ORIGINATION FORM

Proposed Revisions to a Standard Plans Index
(Please provide all information — Incomplete forms will be returned)

Index Number: 455-114

Index Title: 14" CFRP & SS Prestressed Concrete Piles

STRAND PATTERN

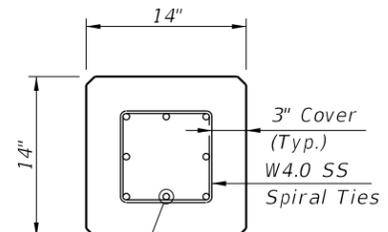
Added 0.6" HSSS strand

12 ~ 1/2" Ø, HSSS at 23 kips
8 ~ 0.6" Ø, HSSS at 35 kips
